215 1ST AVE N - MIXED USE

#3021477

DESIGN REVIEW - RECOMMENDATION PROPOSAL PACKET

REC MEETING: AUGUST 16, 2017

Plan at REC: Typical Level Plans (Levels 2-5)

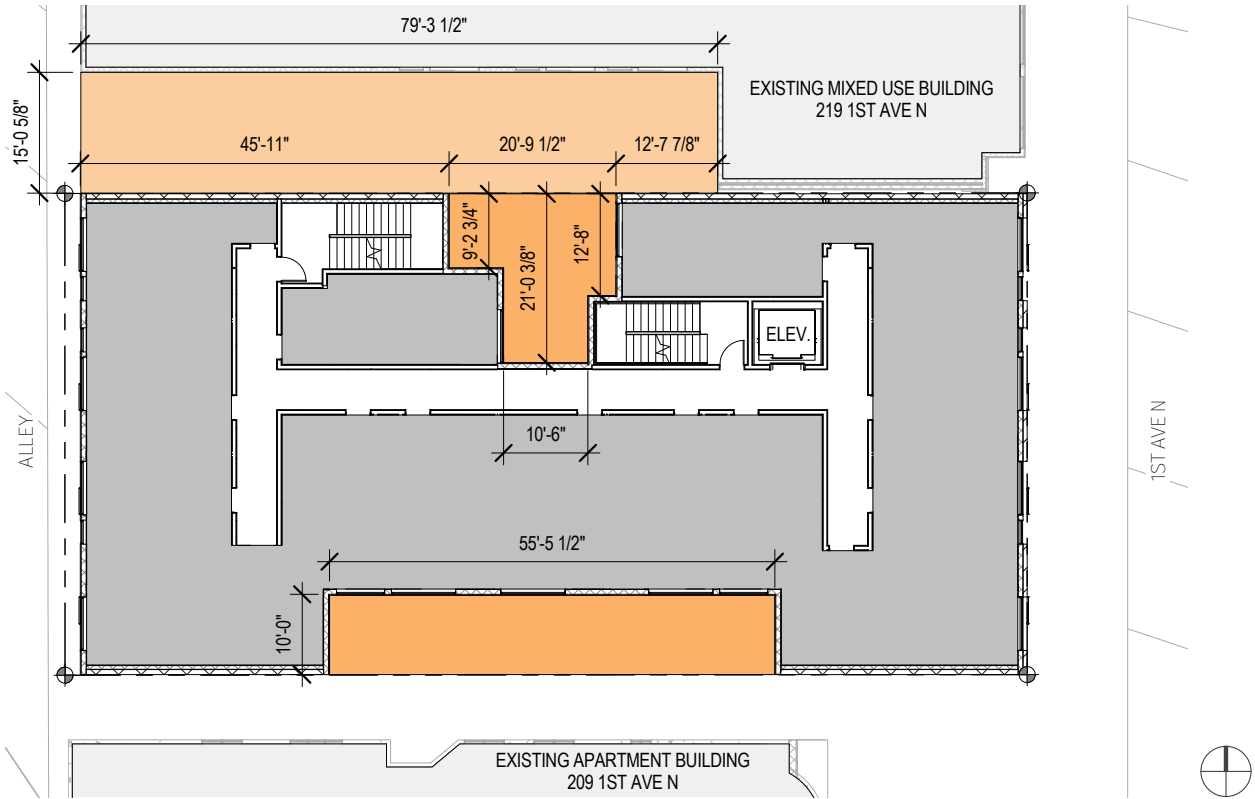
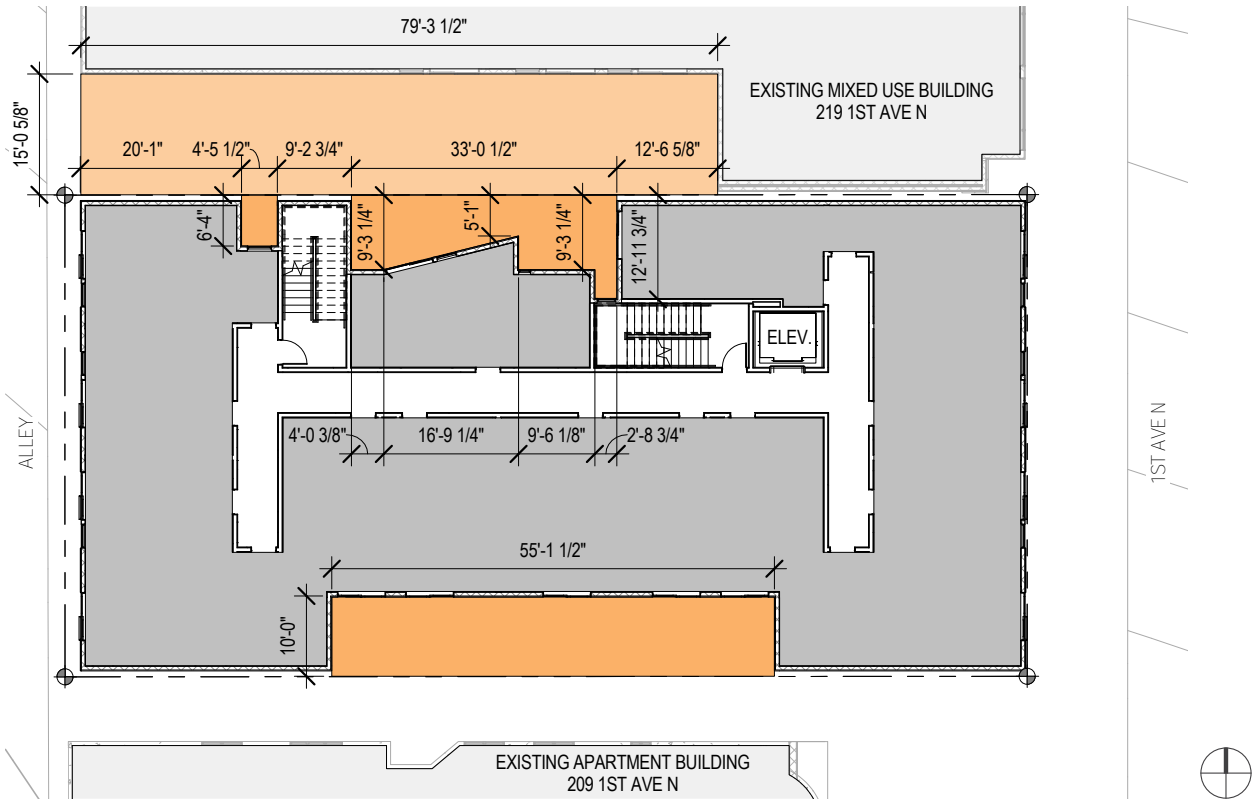
- c. The board agreed with public comment and directed reconfiguration of the building mass along the north facade to be more sensitive to the adjacent site by minimizing blank walls and maximizing access to light. The board directed further study of opportunities for reconfiguration, including shifting stairwells, units, and mass, to allow for a longer, shallower, courtyard along the north property line which better responds to the courtyard and amenity spaces of adjacent development. [CS2.B-3, CS2.C-2, CS2.D-1, CS2.D-5]

DESIGN RESPONSE: The proposal reconfigures the stairwell and two units to provide a longer, more shallow setback along the north property line. The proportion and orientation of the setback helps to reduce the perceived mass of the building and allows for more reflected light to penetrate to the adjacent development.

1st Ave N street elevation looking west.

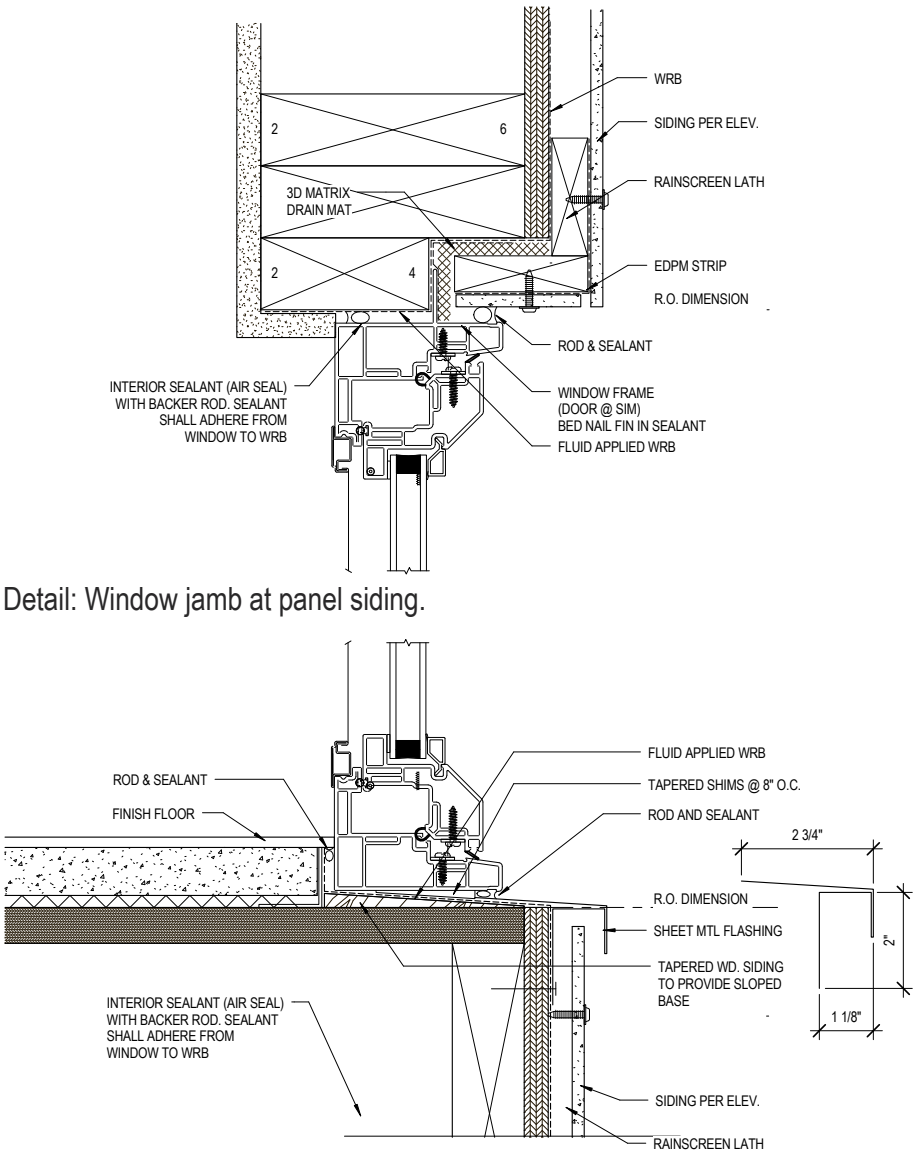
a. Responding to public comment, the board indicated they would like a better understanding of the context and relationship with neighboring buildings, and strongly encouraged a high-level of materiality and deep set windows reflective of the historic architectural context. [DC2.B-1, DC4.A-1]

DESIGN RESPONSE: The proposal is sited in the Uptown Urban character area. This area features a rich variety of historic masonry buildings and large, new construction projects. The overall facade composition is organized in an orderly and evenly-spaced rhythm that is reflective of the historic architectural context. It utilizes materials that share similar proportions and color to brick masonry units. Construction details at the window have been provided to demonstrate that the windows are deep-set into the building facade to create visual depth.

Street-level perspective looking south.

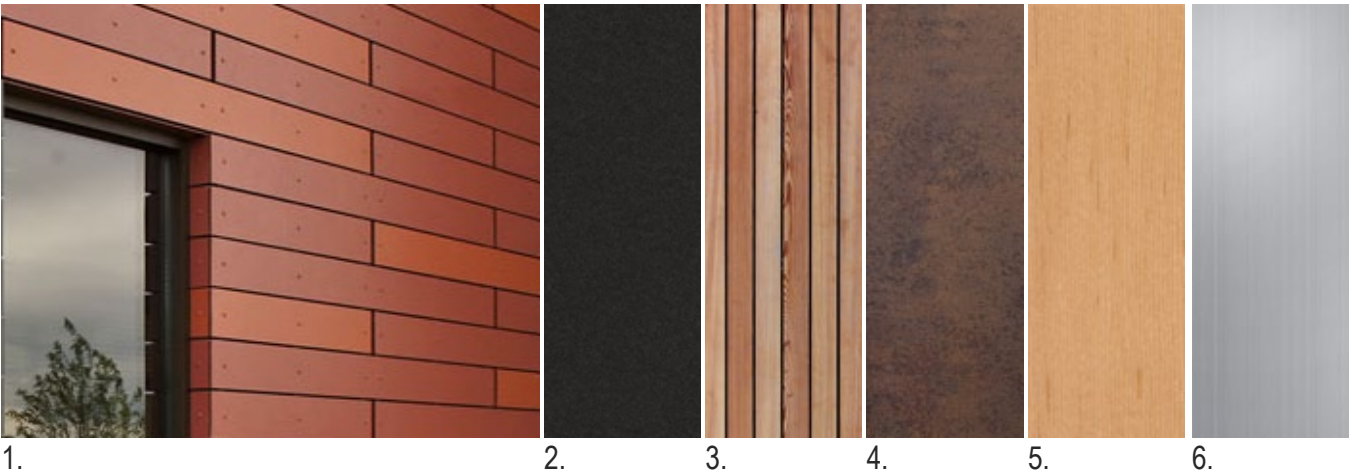
c. The Board did not support the proposed weather protection (canopies) and second-story overhang as they are redundant, create a space for debris to collect and creates a shadow. The board directed incorporation of weather protection into the massing moves. [Cs2.C.2, PL2.C-3, DC2.D.1]

DESIGN RESPONSE: The canopies proposed at EDG have been reduced to singular elements to signify the live-work entries. The primary method of weather protection is provided by a finished wooden soffit at the second story building overhang.

Level 1: Bike storage for frequent riders is located at the ground level common lounge. In addition, a direct line of sight from the stairway to the building entry is required by building code.

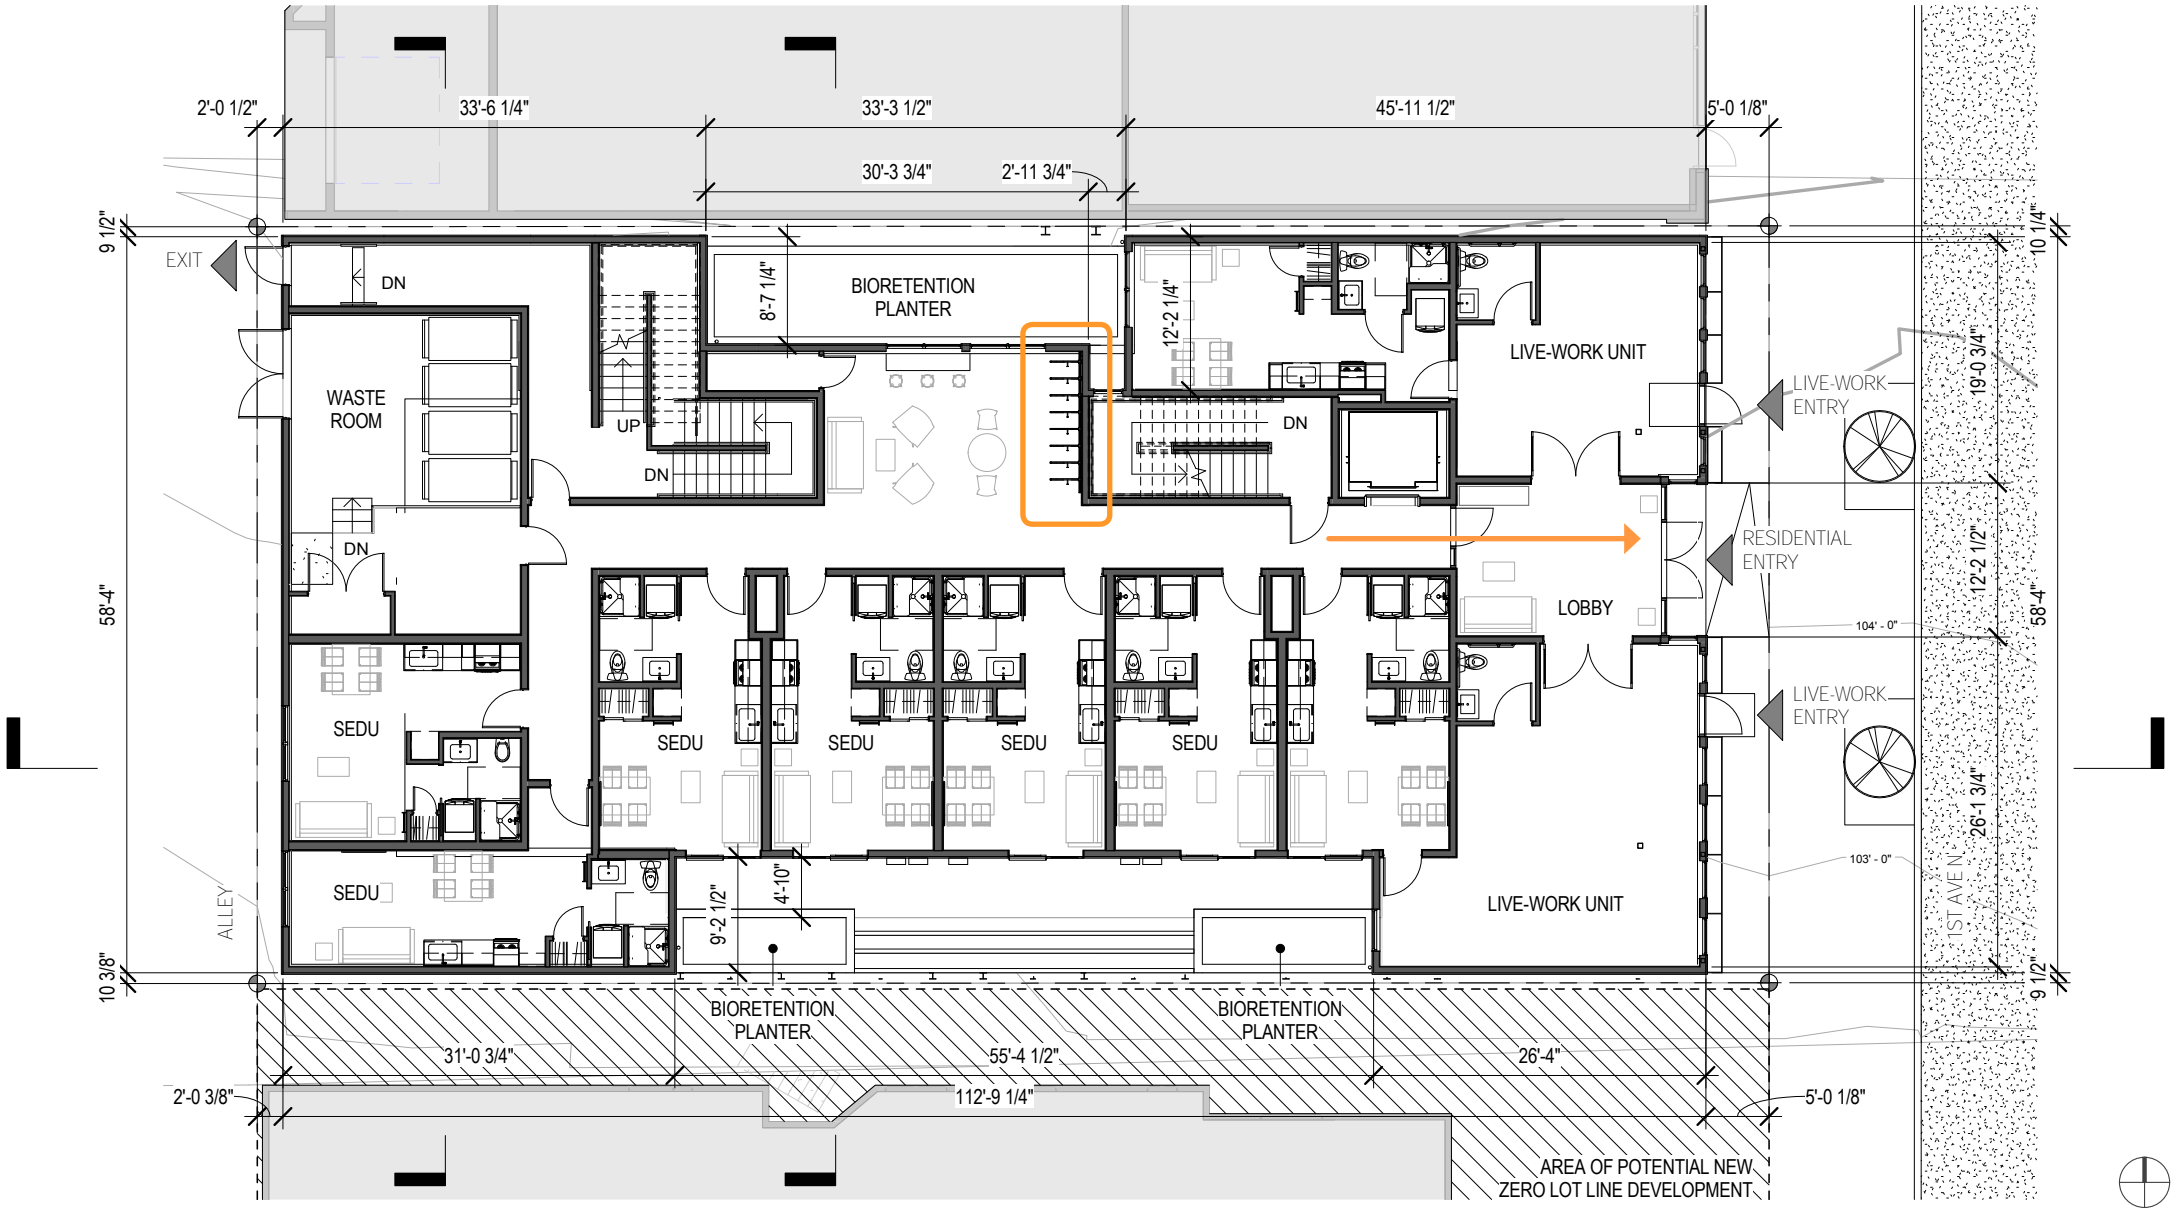
g. The Board identified safe and convenient access to bike storage as a priority. The board did not support the basement location of bike storage, and requested further study of ground floor alley-accessed bike storage. [PI4.B]

DESIGN RESPONSE: The proposal provides a portion of the required bicycle parking at ground level to serve frequent bicyclists. The remainder of bicycle parking is provided in the basement for less frequent riders.
